## TECHNICAL NEWS SHEET

SERIES V No 322DATE 13.5.52.ISSUED FOR THE GENERAL GUIDANCE OF OPERATORS OF DE HAVILLAND AIRCRAFT AND ENGINES  
OFFICIAL INSTRUCTIONS TAKE PRECEDENCE OVER ANYTHING CONTAINED IN THIS BULLETINVAMPIRE AIRFRAME, GENERAL CIRCULATION.  
SUB HEADING 11, ELECTRICAL EQUIPMENT.Circuit Breakers, Type 'A', Stores Ref. 5C/2559,  
60, 61, 62, 63 and 64. Use with Trip Button  
Covers, Stores Ref. 5C/3610.

VAMPIRE AIRFRAME. GENERAL CIRCULATION.  
SUB HEADING 13. RADIO.

### INCREASED DRAINAGE - STUB BOOM.

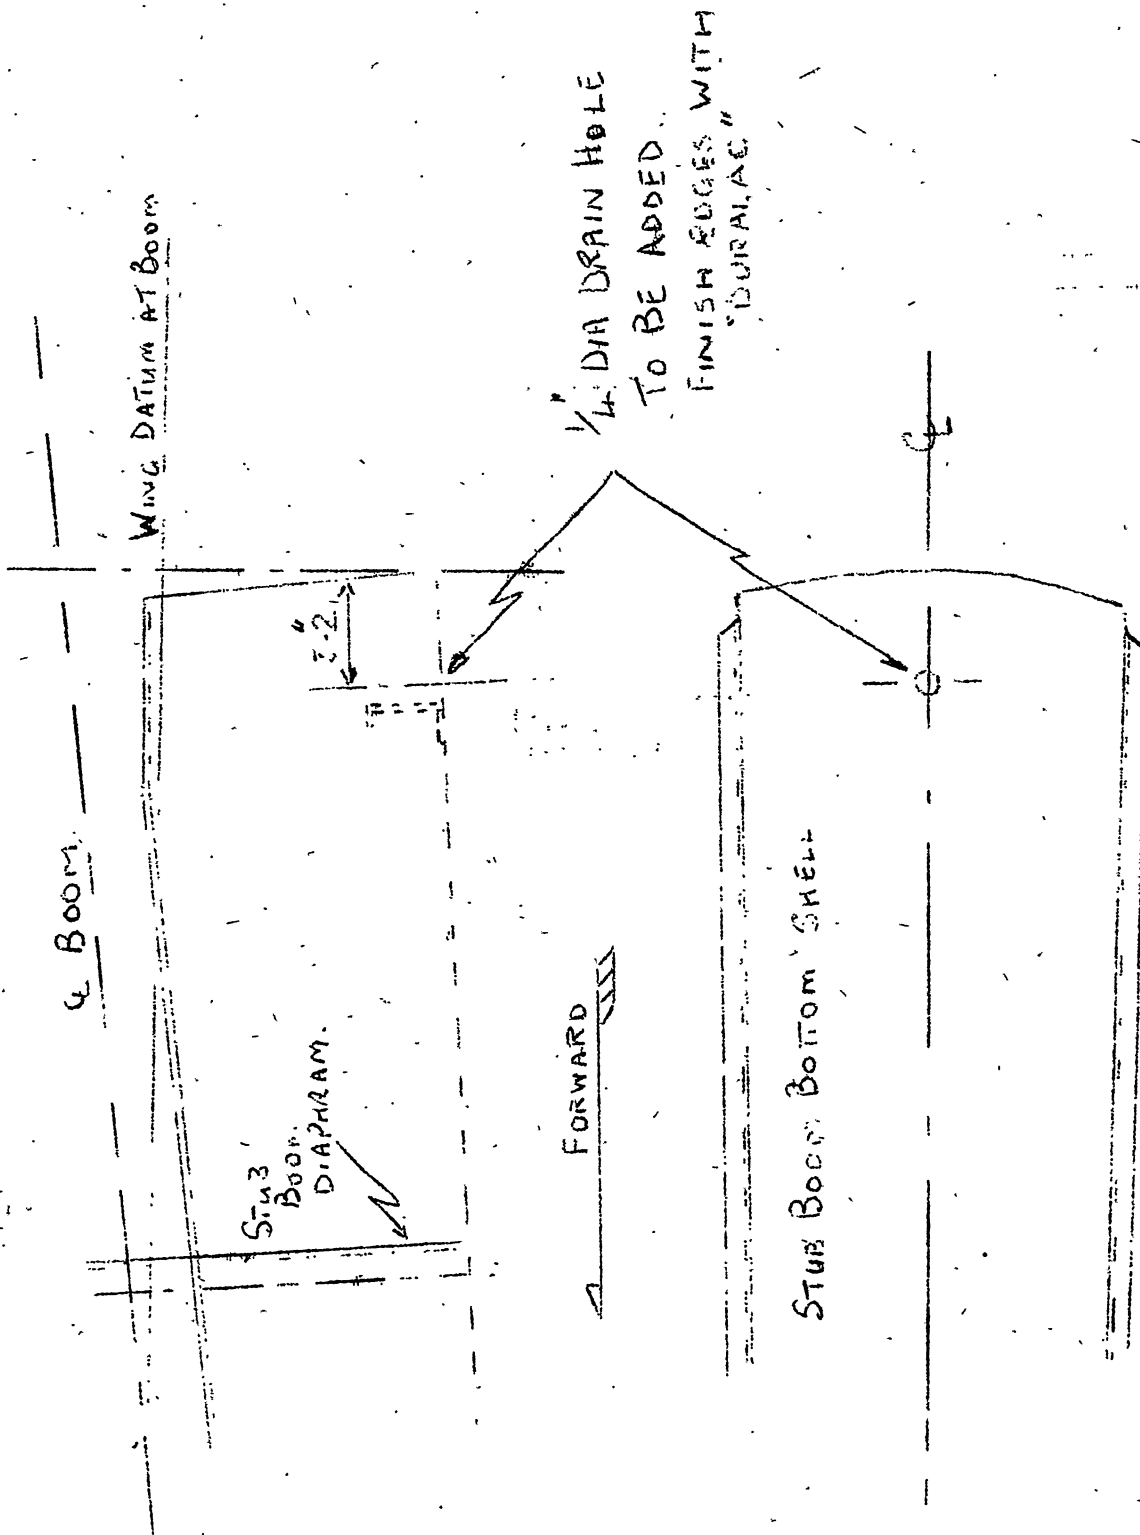
The attached sketch ROD.317 Issue 1, details the position of an additional drain hole to be drilled in the Stub Boom. This is covered by Internal Modification O/2747.

VIEW ON BOTTOM OF TAILPLANE, EXTRA RIVETS REQ'D MARKED THUS:-●  
BOTH ENDS AFFECTED.

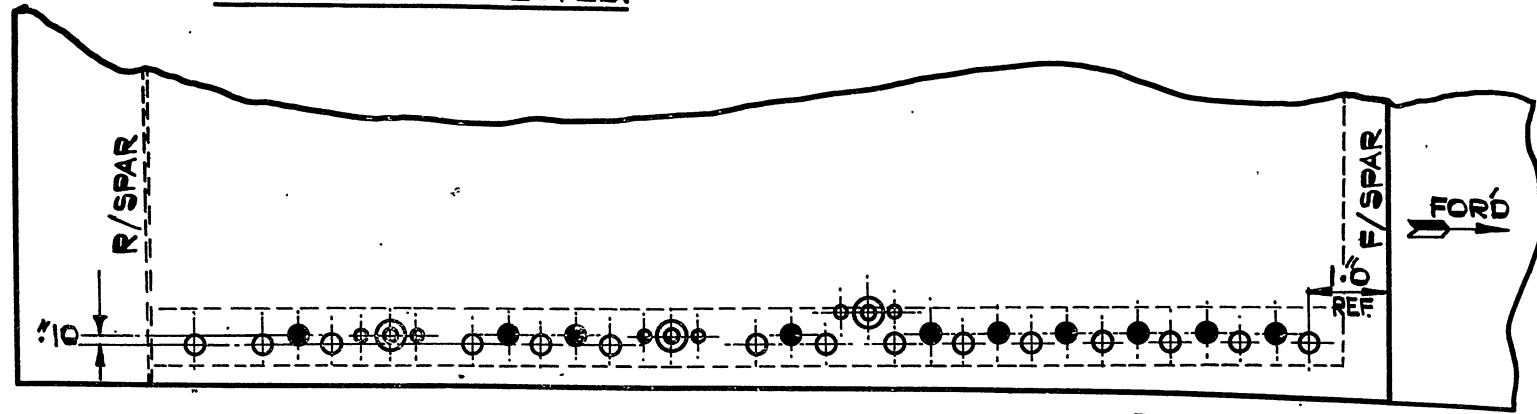
- D) 1. As soon as possible and not later than the next Minor Servicing the following action is to be taken:-
- (i) Remove the tailplane fin fairings and check the size of the rivets through the end ribs in the top and bottom skins shown on drawing R.12.TP.109, Issue 2, attached. These rivets should be 5/32".

- Note 2. Add to drawing attached after "Repair to:- Vampire Aircraft".
- D) 2. Examine and rectify all tailplanes 12.TP.1A held as spares or in store, before issue, and stamp STI/Vampire/56, or STI/Venom/2, as appropriate on the modification plate.

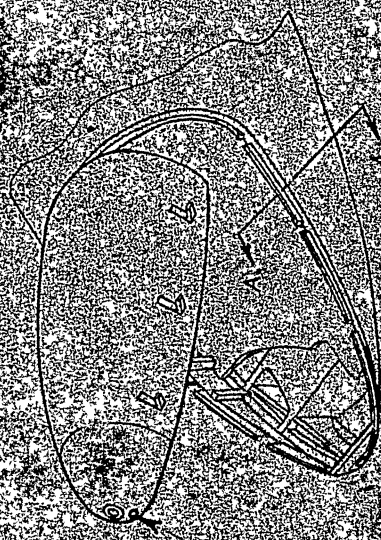
The attached drawing R.15.F.101 details the work involved in improving the fit of the nose and the operation of the nose catch.

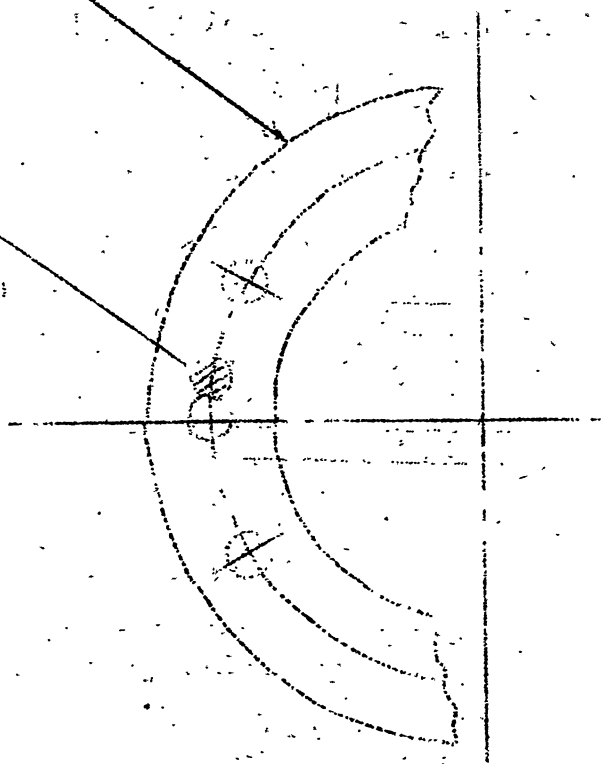
- A) Special Technical Instruction/Vampire/68.  
Re-Rigging of Canopy Winding Handle.
  - B) Vampire Mks.1, 3, 5, and 9. Sea Vampire Mks. 20 and 21.
  - C) Cases have occurred where the canopy has opened in flight.

- D) At the next Primary Servicing the following action is to be carried out in order to provide a safeguard against the canopy opening in flight.
    - (1) Wind the handle hard forward (do not lock the pin into the hole) and then release to find its own position.

- (2) Rig the stop plates to give a one dia. clearance between the pin and hole (refer to the attached drawing in conjunction with (AP.4099c Vol.1, Sect.5, Fig.7 for Mk.3) using the vernier adjustment.

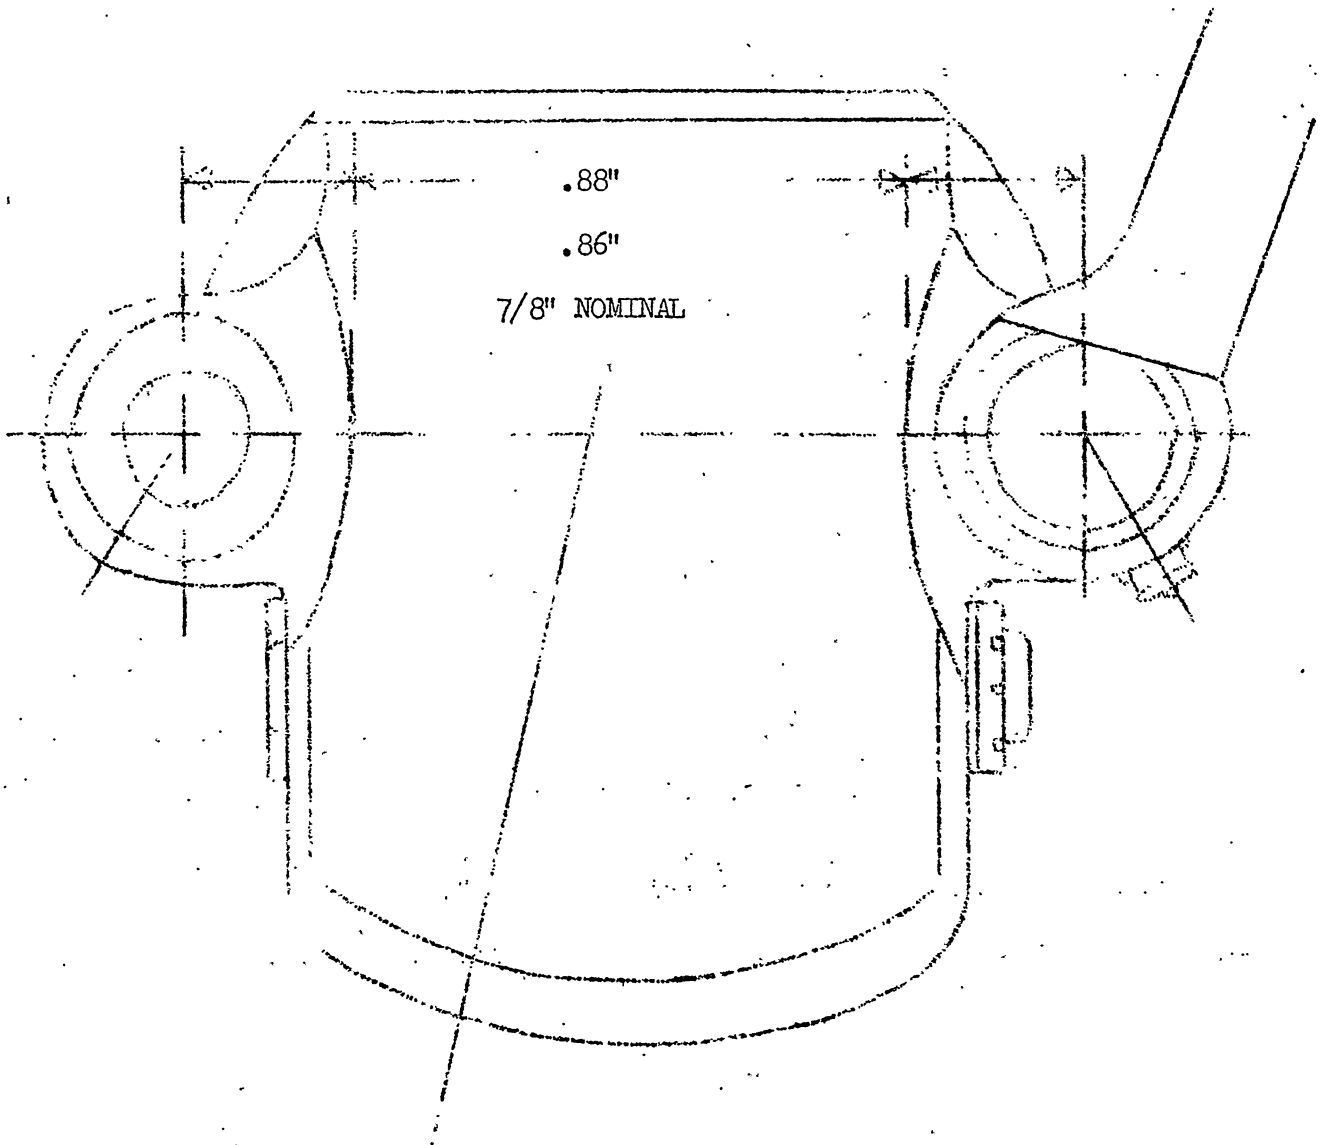
- (v) Sketch attached refers.
- D) 2. Examine all Axles before issue, in accordance with Para (D)1.
- E) Record on appropriate Form.
- F) Report all cases of defect found to R.D.A. Defects, Ministry of Supply.

### TRAINER AIRCRAFT - CONTROL LOCKS STORAGE

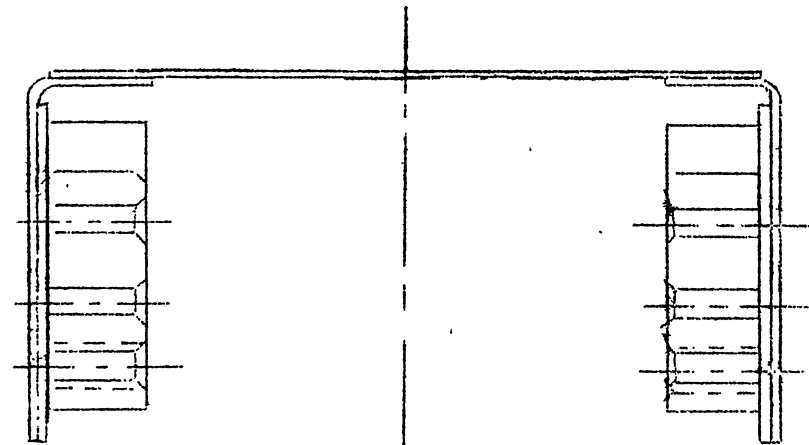
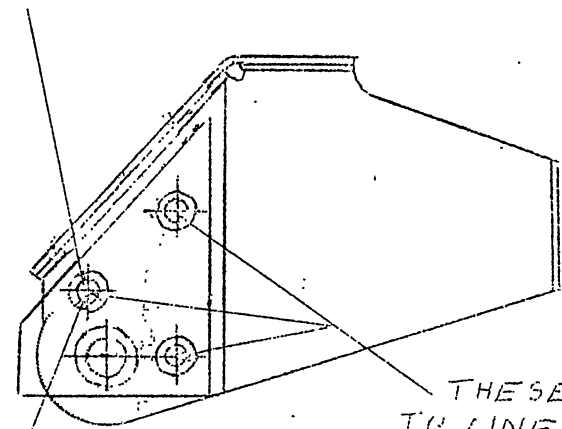
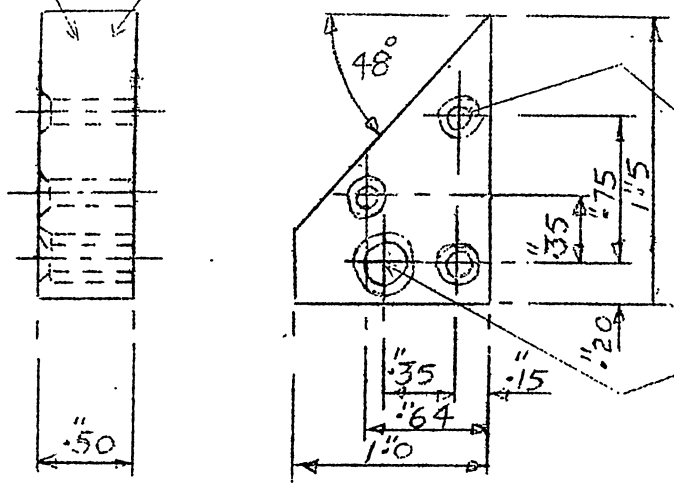
On certain early issue aircraft it may be found that the control lock stowage in the cockpit is too wide to accept the **control lock**. The attached drawing indicates how the stowage may be modified to suit the locks.

DRILL N° 30 HOLE IN BRACKET AND REINFORCING PLATE TO SUIT HOLE IN PACKING

THESE 3 HOLES TO LINE UP WITH HOLES IN EXISTING BRACKET AND REINFORCING PLATE. PT NO 15 F 1329A.

DRAWING NO. ROOG.40. ATTACHED HERETO.

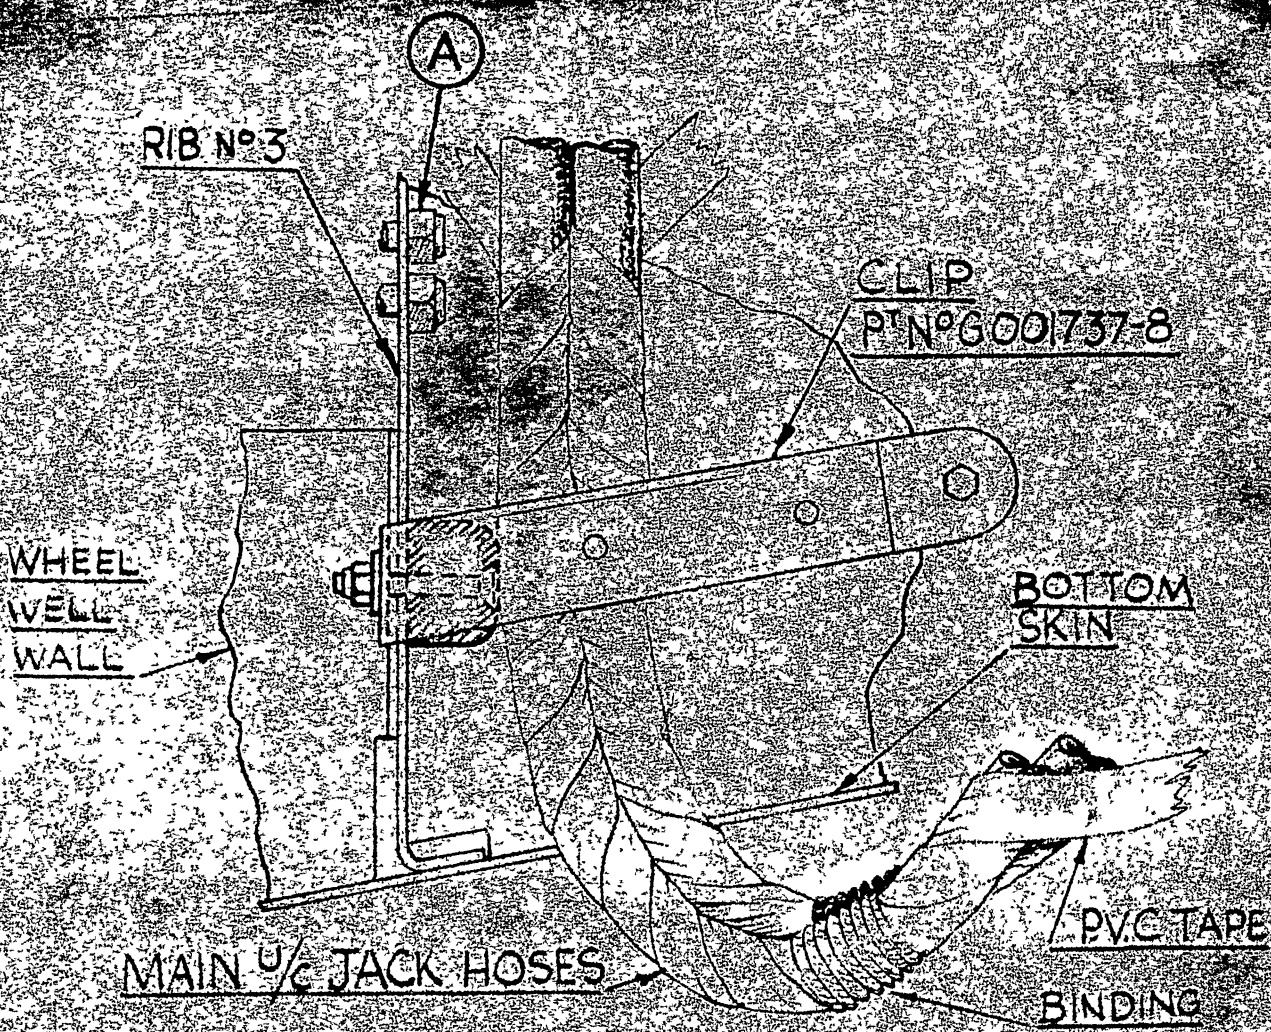
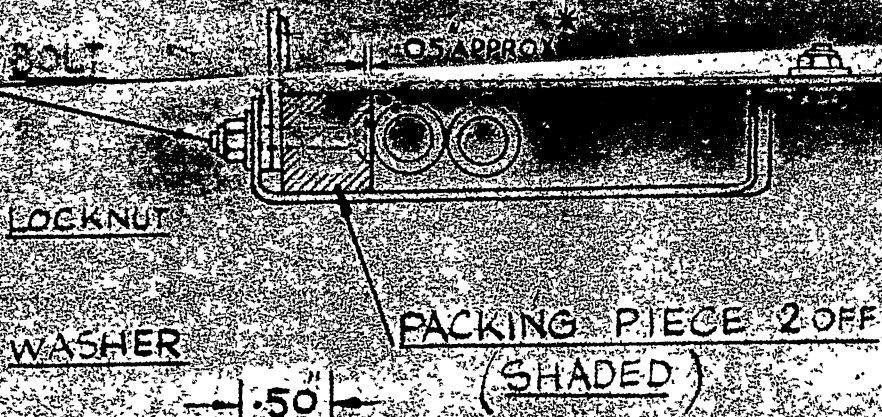
C. It has been reported that the main undercarriage down line, flexible hose, Part No. AIR. 34492 has been chafing on the nuts and threads of the bolts illustrated at "A" on attached drawing ROOG.40 securing the top reinforcing angle on Rib No. 3.

1. Make up a packing block of Tufnol or Fibre to the dimension given on drawing ROOG.40.
2. Remove the 4 BA nut and bolt at the wheel well end of the existing clip Part No. G00.1737-8; fit the block in position and drill the block through the bolt hole.
3. Remove the block again and countersink as illustrated.
4. Fit the packing block with the new M.S. bolt AS.12426B.
5. Inspect P.V.C. tape and hydraulic hose for any sign of damage and replace if necessary

U/C DOOR UP LOCK SETTING & ADJUSTMENT DIAGRAM

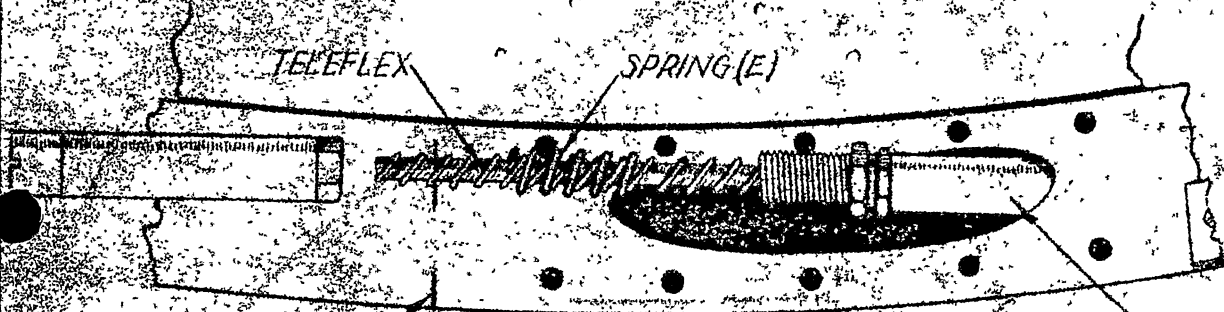
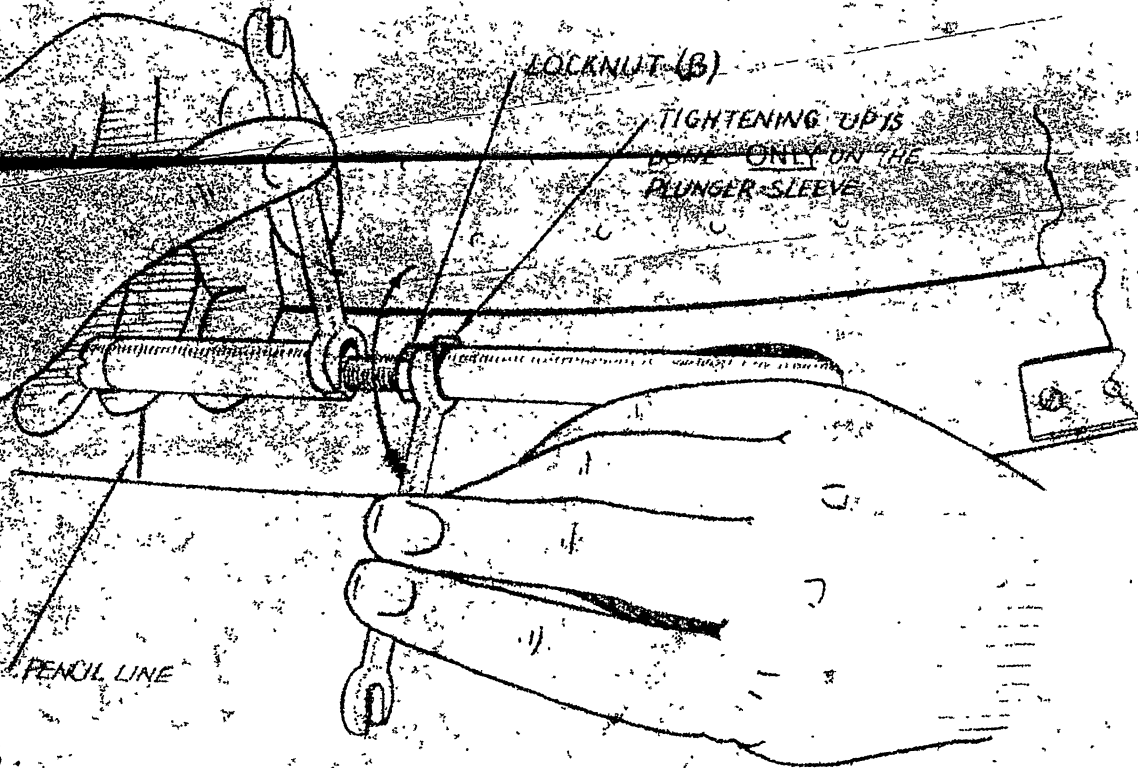
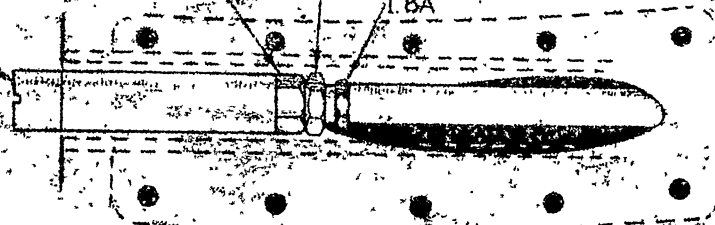
(4) Adjustment Mark a pencil line on the structure level with the end of the plunger guide (A) as shown in Fig.1. Disconnect the undercarriage door and remove the wheel.

HANDWHEEL MARKINGS

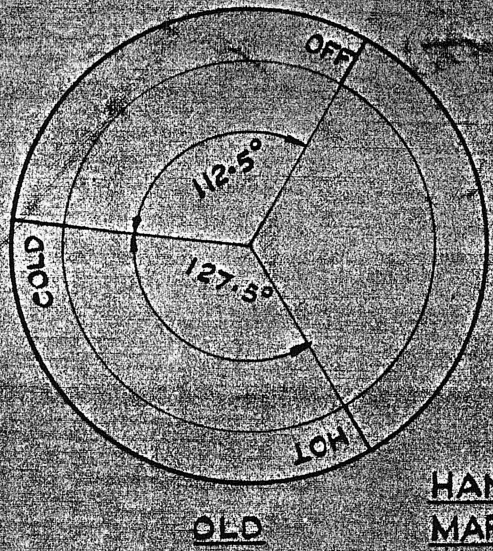
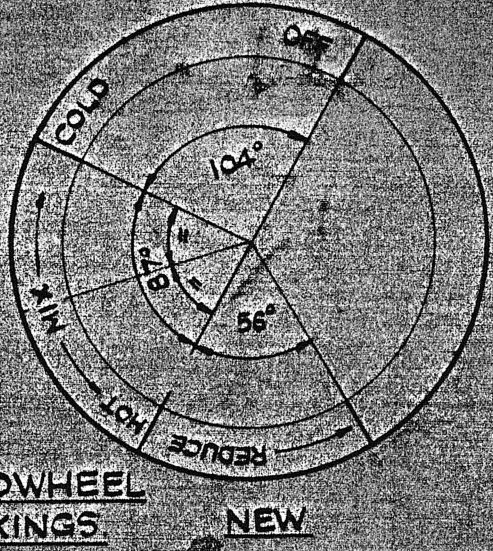
DUE TO INCORRECT MARKING OF THE COCKPIT TEMPERATURE CONTROL HANDWHEEL 15 CE 497A ANGULAR MOVEMENT ON CAMS DOES NOT PRODUCE CORRECT TEMPERATURE CONTROL AS THERE IS NO PERIOD OF MIX (COLD & HOT) OR REDUCE (FROM HOT TO OFF). THE HANDWHEEL SHOULD NOW BE RE-MARKED AND CAMS SHOULD BE RE-SET AS ILLUSTRATED BELOW.
